TORONTO TRANSIT COMMISSION AND THE CITY OF TORONTO
NOTICE OF PREPARATION OF AN ADDENDUM REPORT
To The Spadina Subway Extension
Downsview Station to Steeles Avenue Individual Environmental Assessment (EA)
Relocation of Train Storage Structure
Toronto-York Spadina Subway Extension Project (TYSSE)

Source: TYSSE, March 2010

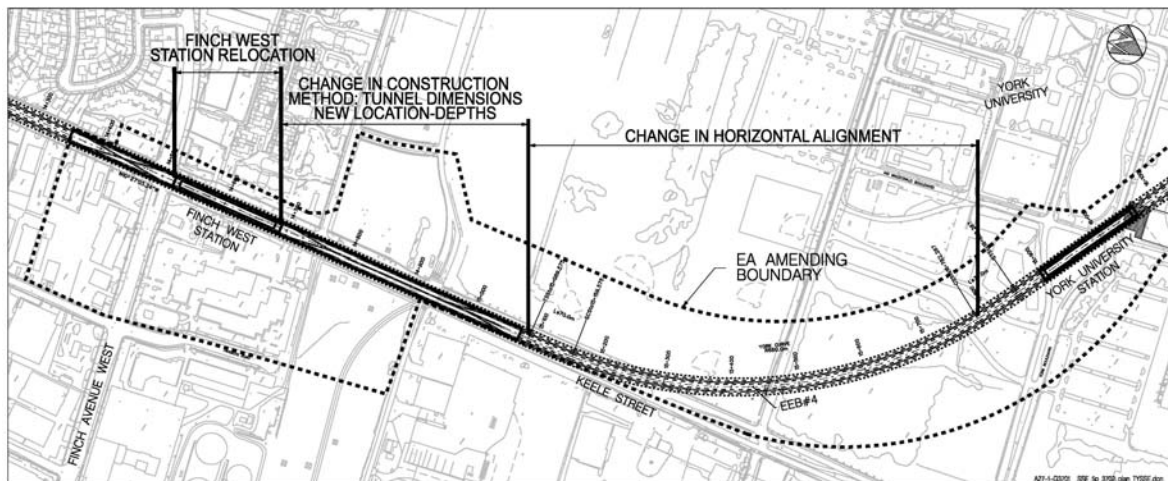
The Toronto EA details train storage capacity and train turn around locations at the Steeles West Station. Detailed design work, schedule and budget constraints led to the proposed relocation of the train storage structure from the Steeles West Station area to the tunnel alignment under Keele Street, north of the Finch West Station and beneath the Richview-Cherrywood Hydro Corridor. The train storage capacity is now proposed to be provided through a double ended pocket track housing structure (DEPTHS). The following change requires the preparation of an Addendum Report:

- A change in the location, width and the construction method of the DEPTH structure.
